**HOWELL TOWNSHIP PLANNING COMMISSION
REGULAR MEETING**

DITCH WITCH EXPANSION

RE: Ditch Witch Expansion
Parcel ID #4706-28-200-040
Preliminary Site Plan Review, Second Review

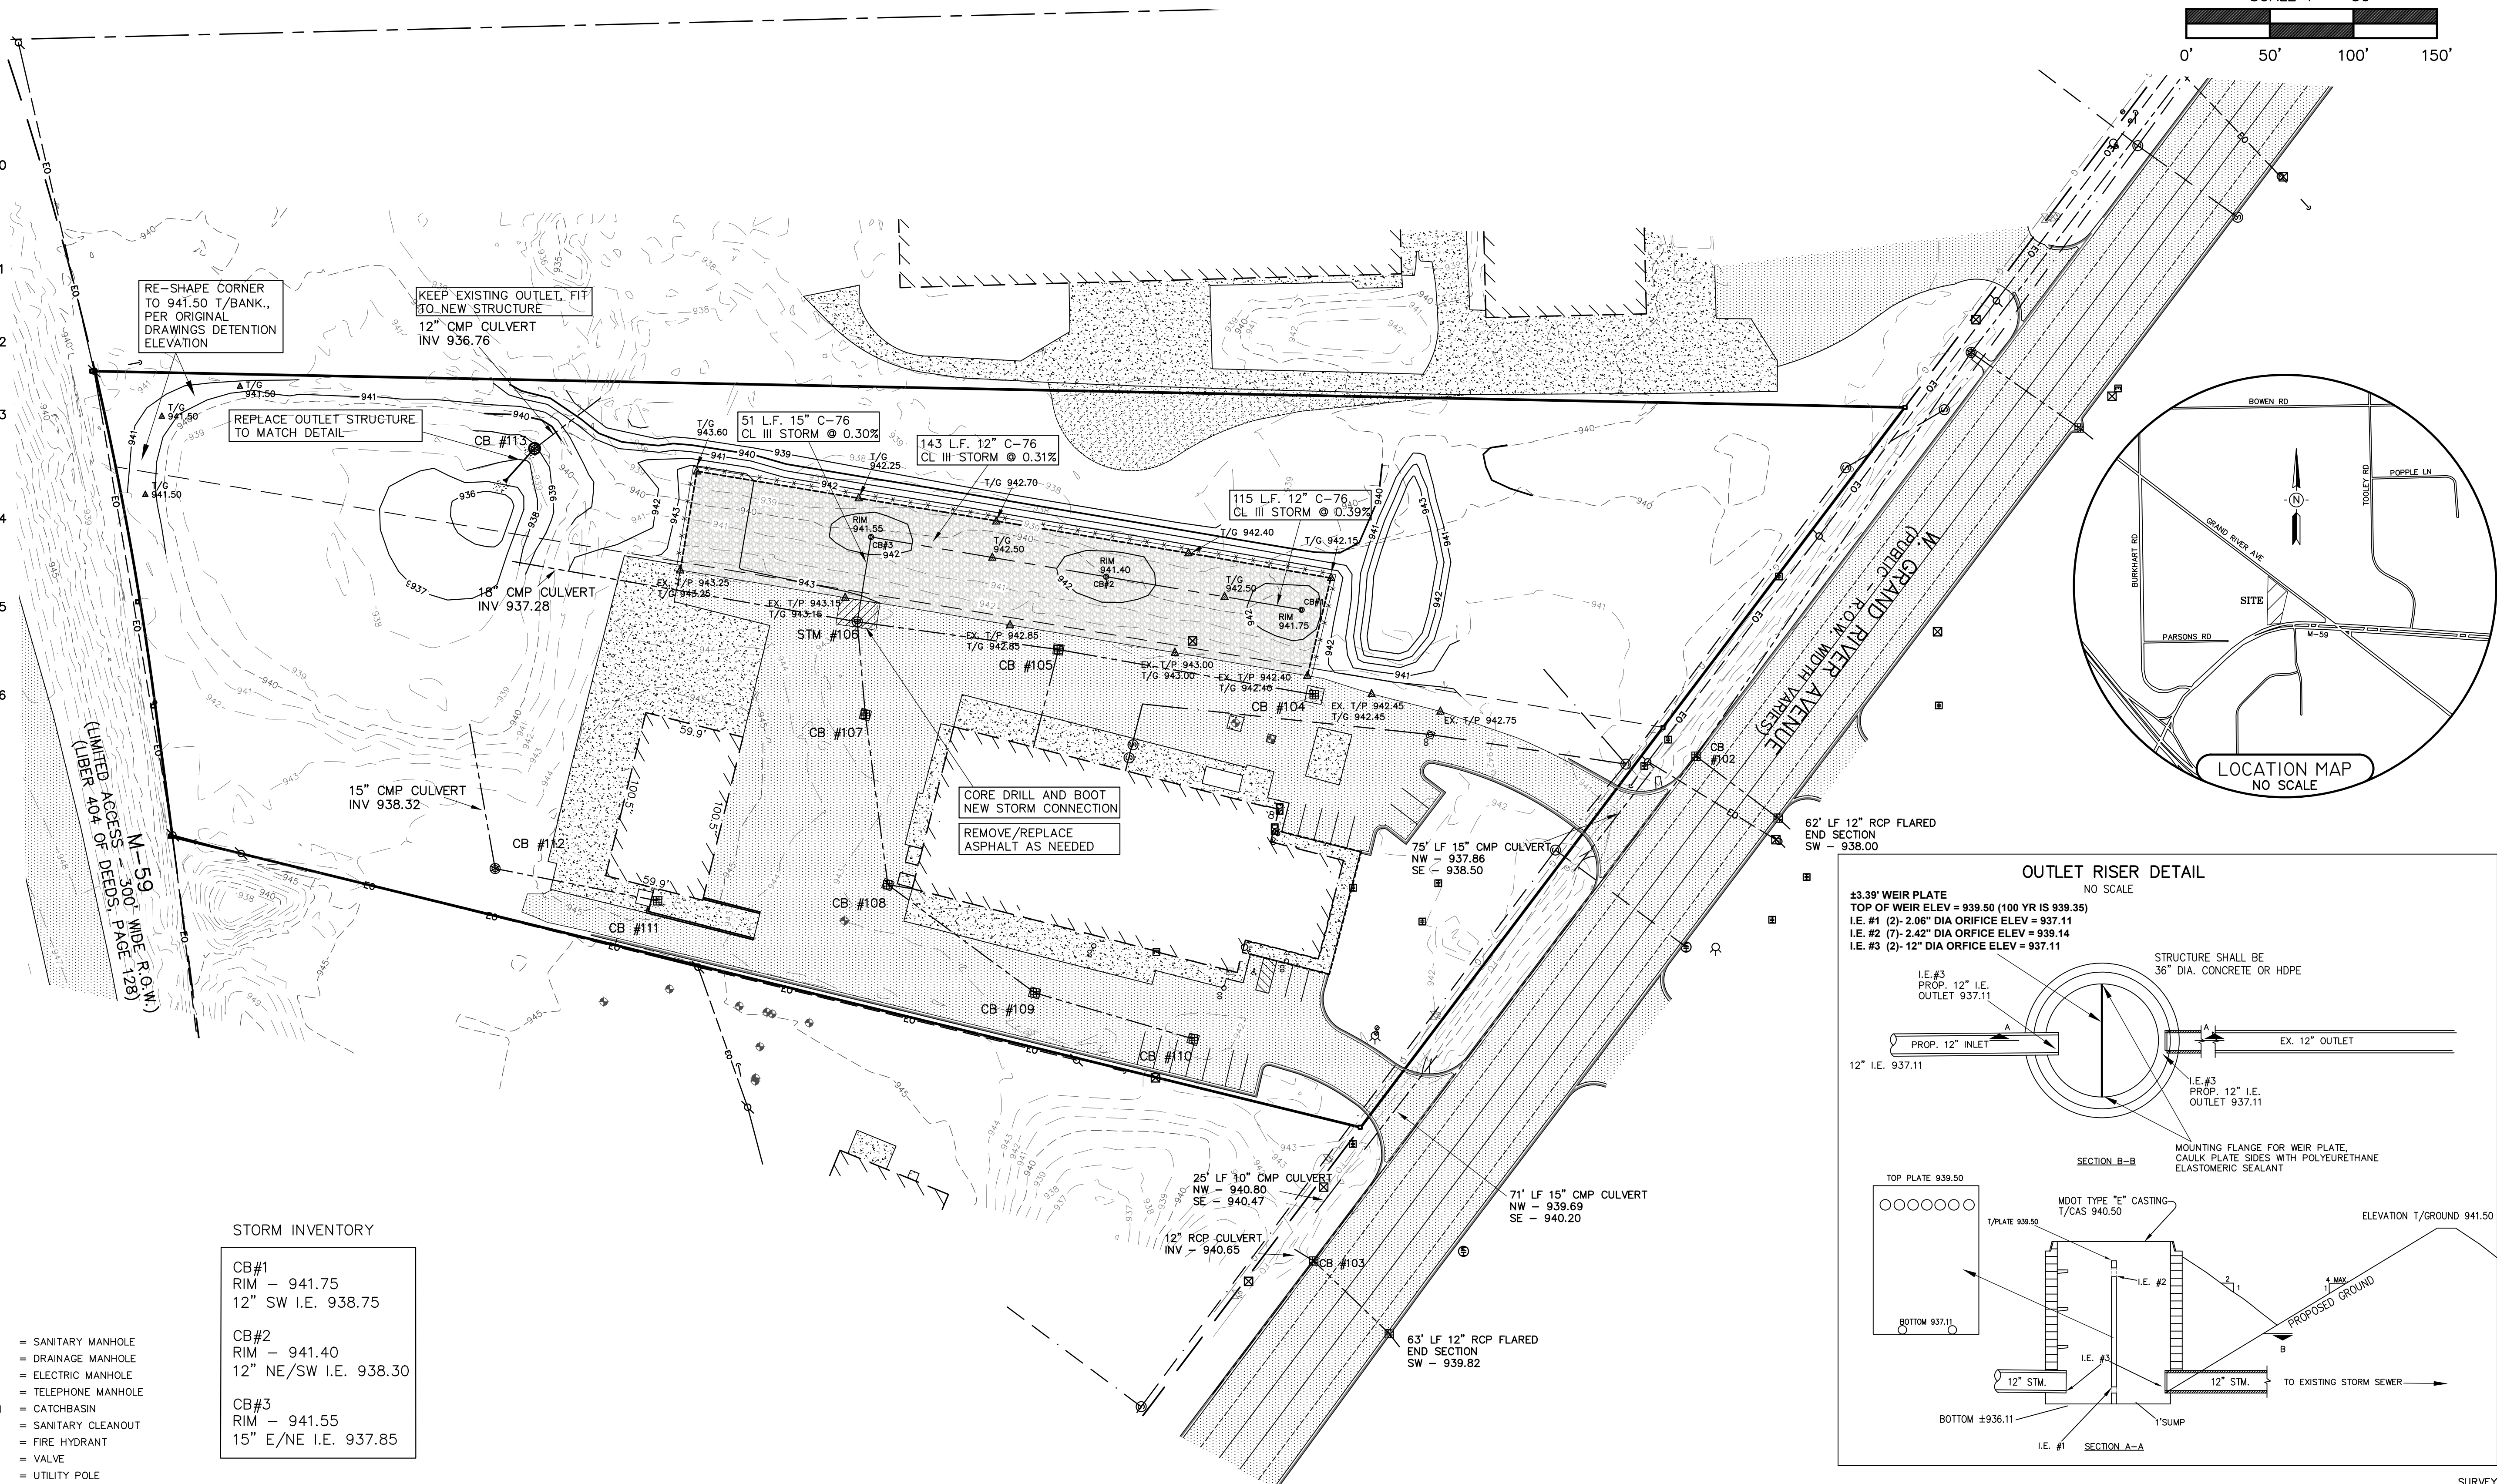
A perimeter fence is shown surrounding the proposed outdoor storage area. Prior to Final Site Plan approval, details regarding fence type, material, height, and opacity shall be provided and reviewed by the Township to confirm that the fence achieves the required screening from public view and adjacent

Existing drainage patterns shown on the plans indicate that runoff generally flows toward the on-site stormwater management facilities. The plans indicate minor grading along the west side of the proposed expansion that doesn't significantly change the runoff characteristics of the unpaved areas. Runoff from the proposed gravel outdoor storage area is directed to existing stormwater infrastructure and discharges to the existing on-site detention basin. No new off-site discharge points are proposed. The improved site will require 39,733 cubic feet of stormwater storage and 105,290 cubic feet are provided, sufficient for the project. Detailed grading and stormwater calculations have not been evaluated at this stage and shall be submitted and reviewed as part of the construction plans.

1. Plans are to be submitted and reviewed by the Fire Marshal, Township Planner and Livingston County Drain Commissioner.
2. The grading along the West side of the site has been revised. The gravel section was reduced to 60' and the gravel section is proposed to all be captured and sent to the existing detention basin. The West side of the gravel will remain drainage as-is. It currently is flat but ultimately goes to the SW. With the gravel collecting all the proposed runoff, the drainage to the SW will be reduced.

DITCH WITCH EXPANSION
LANDSCAPE PLAN

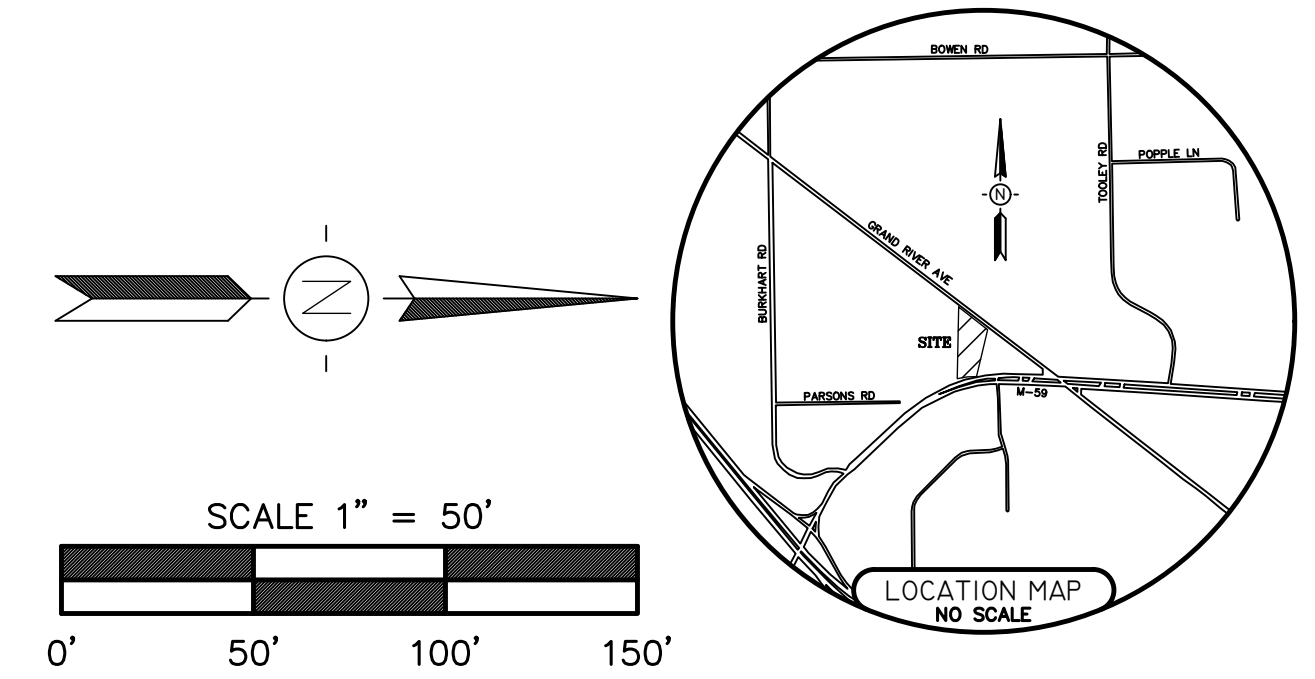
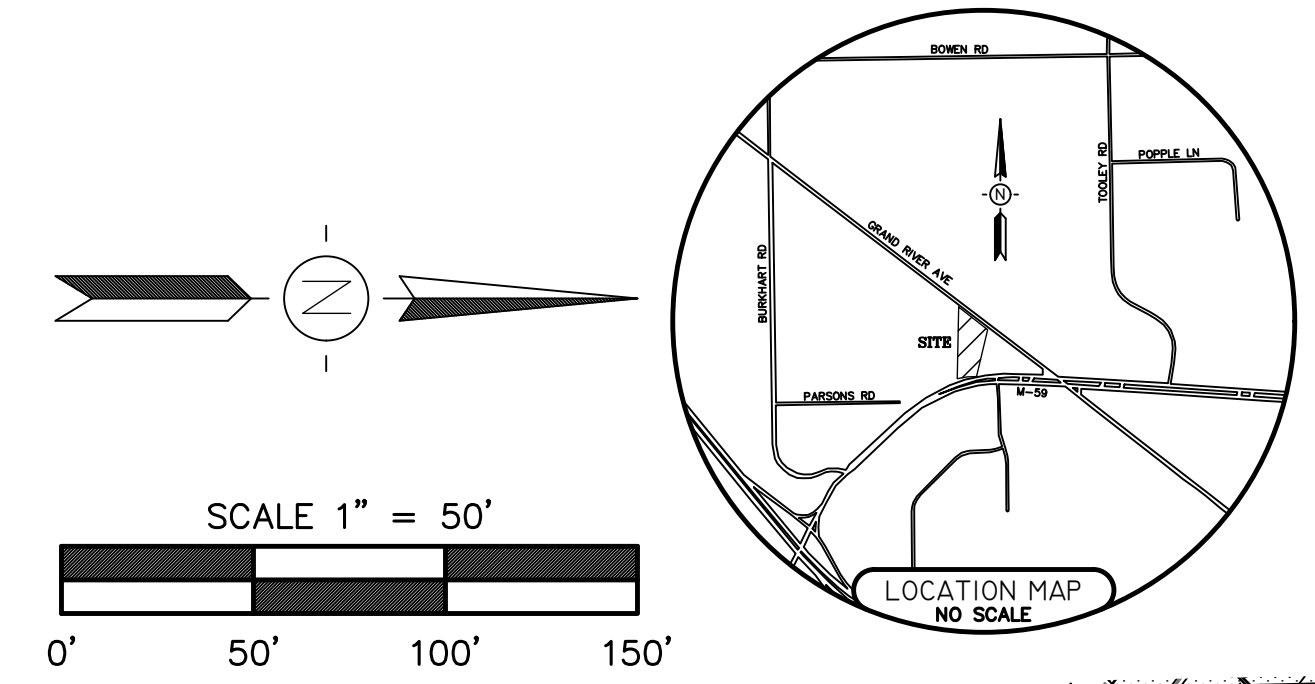
A Landscaping Plan has been provided on Sheet 6. Landscaping requirements are noted in **Table 3** are representative of the entire site.

The applicant requests to only landscape the proposed expansion area for the front yard landscaping along Grand River. This will consist of two hundred (200) feet according to Sheet 6.

7. The number of parking spaces have been added to the site data table in both the coversheet and the site plan.
8. A berm between the gravel storage expansion area and the right-of-way has been added to the site and grading plan and is detailed on the landscape plan. Since this site is already developed and landscaped along the frontage we are looking to add the berm/trees/shrubs immediately in front of the proposed gravel storage area only.

9. Parking lot landscaping has not been provided since there is no proposed parking anymore.
10. Deciduous and ornamental trees have been added along with shrubs based on calculations from the property line to the edge of the proposed expansion to calculate the number of trees and shrubs need to be added to the landscaping plan along with a table showing all these calculations.

11. The building frontage on the Grand River side is approximately 60 feet. 2 trees and 9 shrubs have been shown in front of the building in a planting bed.
